**Docket Item #2**  
**Design Review Board Case #2009-0002 (Advisory only)**  
**EESAP Blocks 11 & 12 - 2210 Eisenhower Avenue**

Application	General Data	
<b>Project Name:</b> Eisenhower East Blocks 11 & 12	<b>Site Area:</b>	Block 11: 122,115 sf (2.80 ac) Block 12: 60,062 sf (1.37 ac)
	<b>Zone:</b>	CDD#2
	<b>Proposed Use:</b>	Block 11: Residential & Retail Block 12: Residential & Retail
	<b>Gross Floor Area:</b>	Block 11: 617,875 sf Block 12: 533,200 sf Total: 1,151,075 sf
<b>Location:</b> 2210 Eisenhower Avenue	<b>Small Area Plan:</b>	Eisenhower East
<b>Applicant:</b> Hoffman Company, represented by Joanna Frizzell of McGuireWoods LLP	<b>Green Building:</b>	LEED Certified

Purpose of Application
Concept design <b>review</b> of a development proposal for two blocks in the Eisenhower East Small Area Plan area. The proposal includes construction of two residential mixed-use buildings at the intersection of Port Street and Eisenhower Avenue adjacent to the Eisenhower Metro Station.
<b>Staff Reviewers:</b> Tom Canfield, AIA <a href="mailto:tom.canfield@alexandriava.gov">tom.canfield@alexandriava.gov</a> Natalie Sun, AICP, LEED AP <a href="mailto:natalie.sun@alexandriava.gov">natalie.s

Figure 1. Ground floor and garage ramp study by City staff.

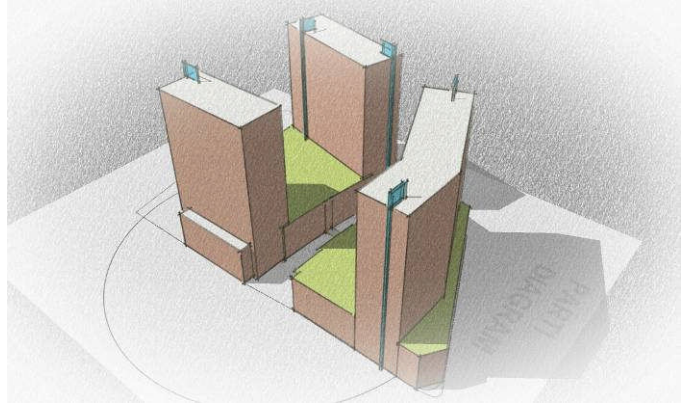
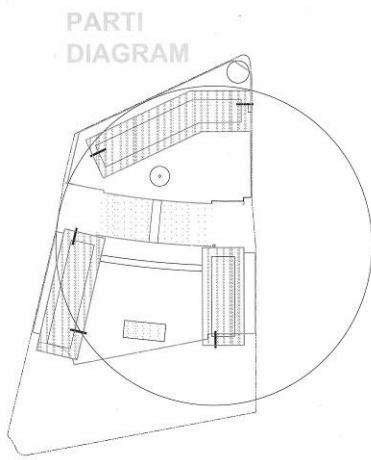
The site plan currently shows four access points to garage ramps (two per block face) as well as access to an internal surface parking lot on Block 12. Staff has been encouraging the applicant to reduce the number of garage access points on Dock Lane as required by Conditions 125 and 129 of the Stage 1 DSUP to make the street more pedestrian friendly and to possibly allow more active use/retail on the street. Staff believes that two garage ramps could be located on Port Street and has expended a substantial amount of time demonstrating that the ramps can function in this location.

Staff continues to feel that the evolving character and location of Dock Lane through this project warrants exploring the redesign of the ramping system to allow engaging the street with active/retail use to the greatest extent possible. The potential gains, which include exposure for Harris Teeter on Dock Lane, increased retail frontage, increased on-street parking on Dock Lane, and removal of the garage ramps from the building faces, outweigh the adverse impact of additional curb cuts on Port Street.

*Applicant's scheme*

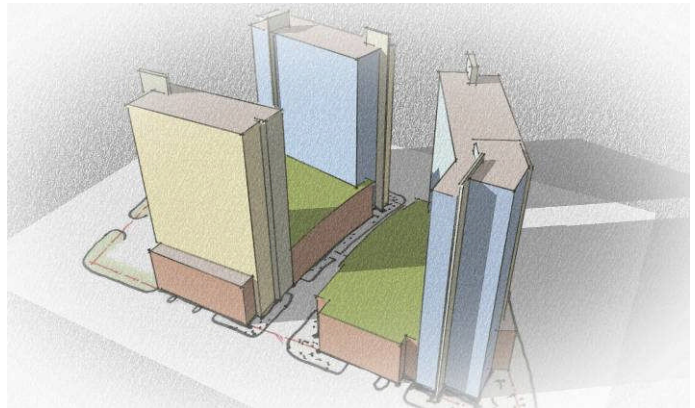
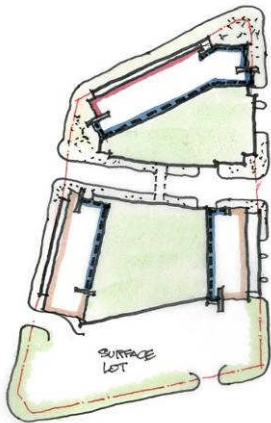
The overall building massing is boxy in appearance, projecting an image of three utilitarian vertical slabs. The tower slabs appear too similar to each other, with minimal articulation, nondescript roof features, and uniform heights. Since the treatment of the horizontal bases is generally consistent throughout all three building facades, they in fact emphasize the sameness of the building massing. This all leads to an overall impression of three unarticulated vertical slabs on top of a podium base. As one of the major new building projects being planned for the Eisenhower East district, this development should play a major role in shaping the Eisenhower East skyline and needs a more dynamic and articulated massing plan. Staff has studied the applicant's proposal through a series of parti diagrams shown in Attachment A.
